MBARI
COMMENTS ON FINAL DESIGN SPEC. (DRAFT) Rev 0.0
TIBURON II ROV SYSTEM

Document: EJ47 Comments on draft tech spec rev0.0

The following comments are based on the MBARI document entitled 'MBARI's Tiburon II Final Design Specification (DRAFT) Revision 0.0'. The item and title in the table of section 2 of this document reflects the sections of the MBARI specification and the table should therefore be read in conjunction with the MBARI specification.

NOTES :-

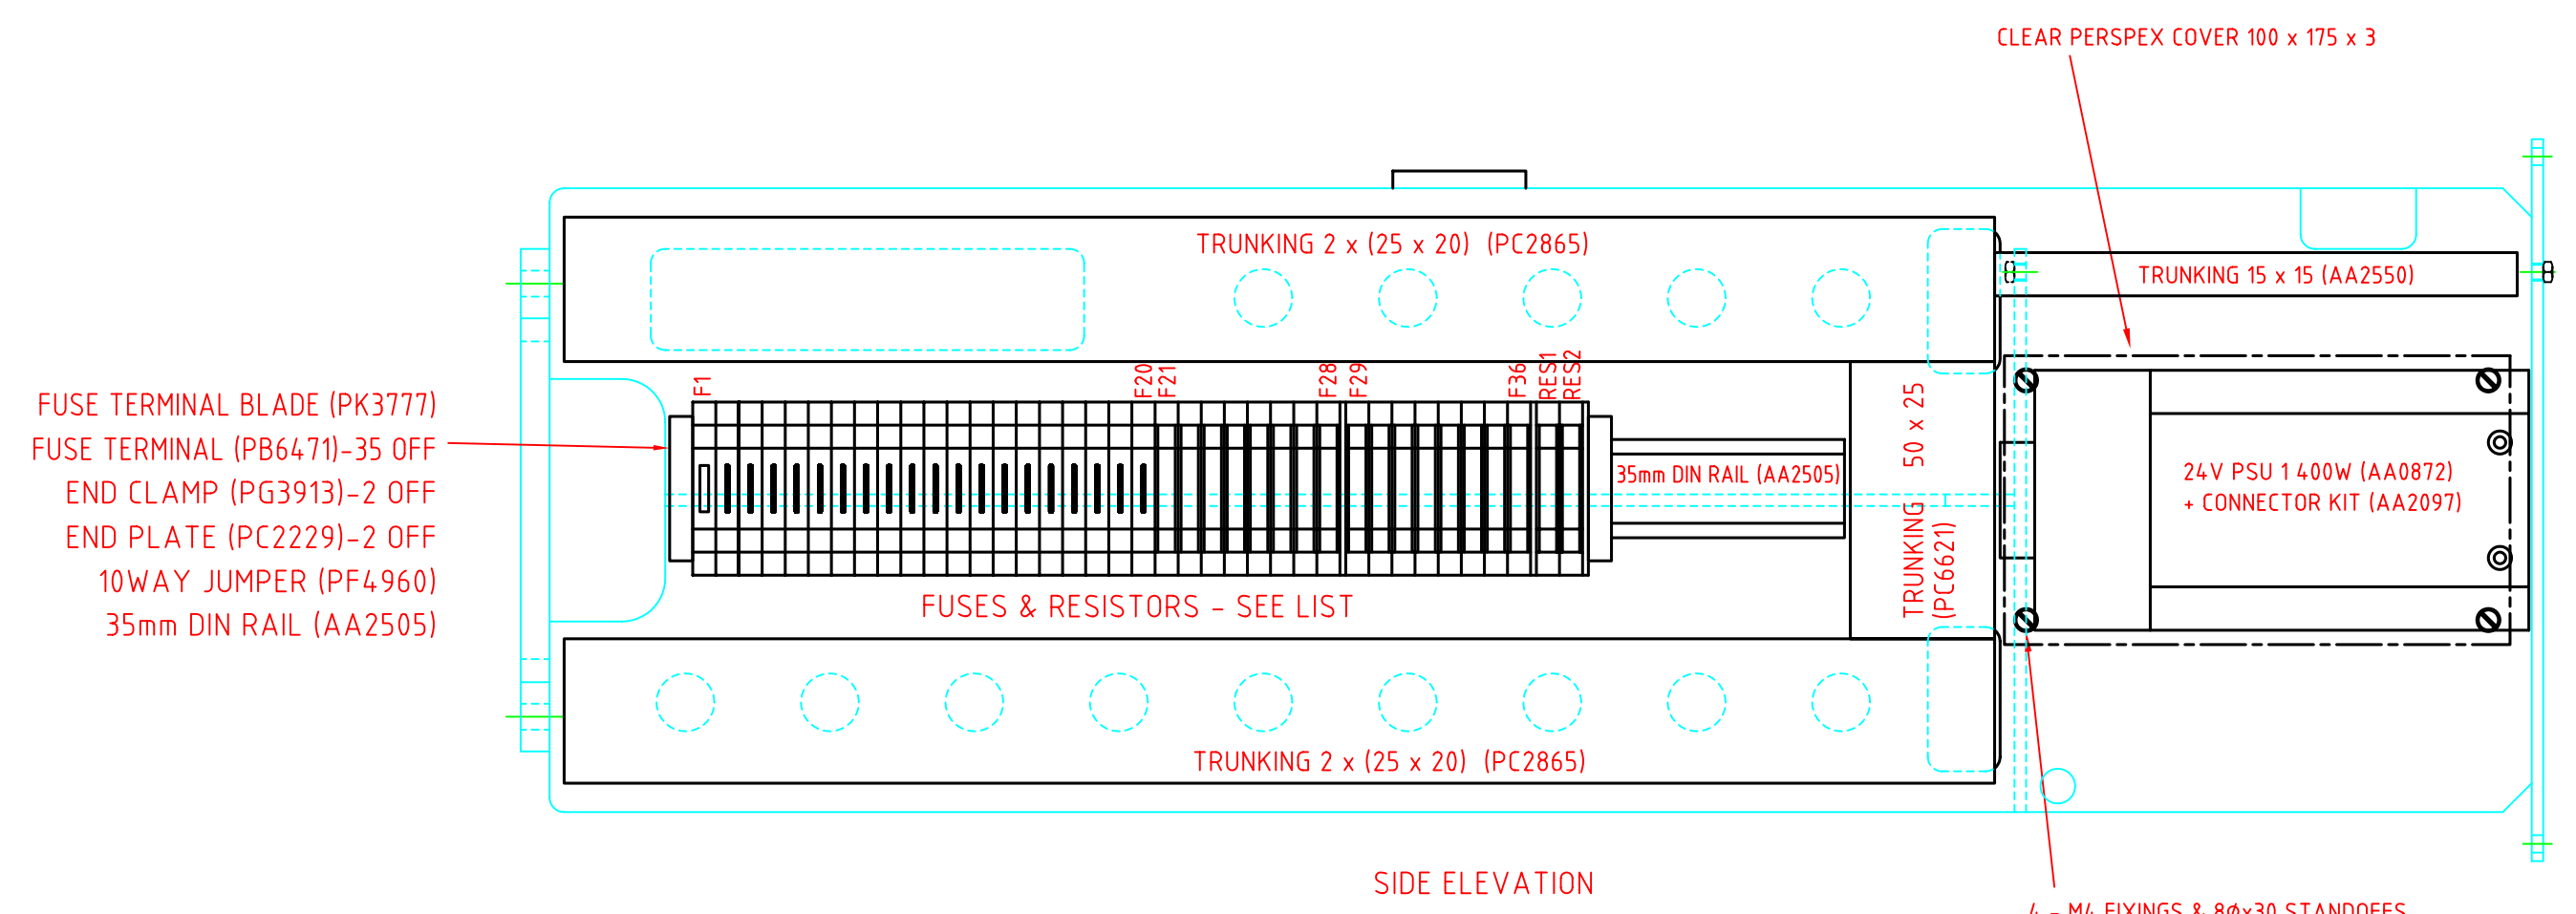
2.2.2	Sub-Sea Control Pod	A general arrangement drawing of the inner chassis of a Quantum electronic pod is provided as an example.
2.2.2.1	Connectors & cables	Agreed
